HIROSE ELECTRIC CO., LTD.
2-6-3 Nakagawa Chuoh, Tsuzuki-ku, Yokohama, JAPAN

JR13W-3-core, JRC21-17-core receptacle, HR08-42-core receptacle Additional hole in soldering area

■Product list PCN2024-08_JR13W-3-core, JRC21-17-core receptacle, HR08-42-core receptacle Additional hole in soldering area

Terminal Shape Change Details

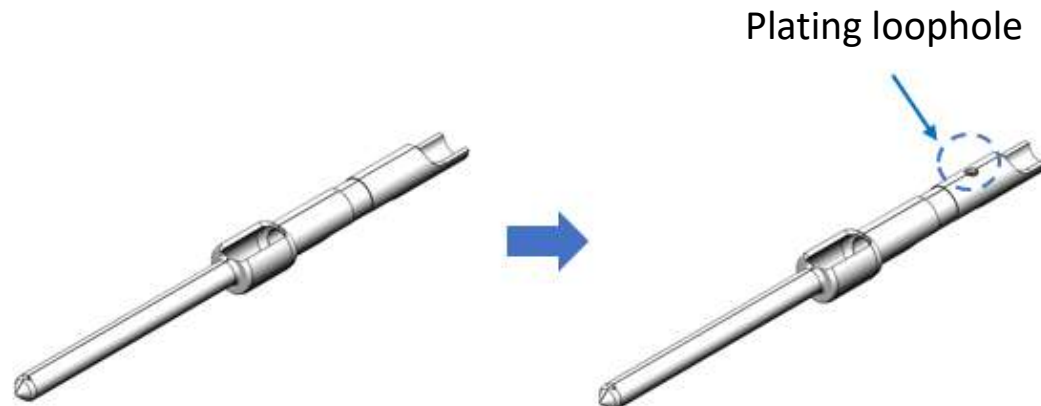
Changes : Additional plating loop hole in terminal soldering area

Air bubbles and other bubbles accumulate in the plating process at the soldering area of terminals, causing process defects that do not allow sufficient plating to be applied. Therefore, to improve productivity, plating loop holes are provided and the shape of terminals is changed.
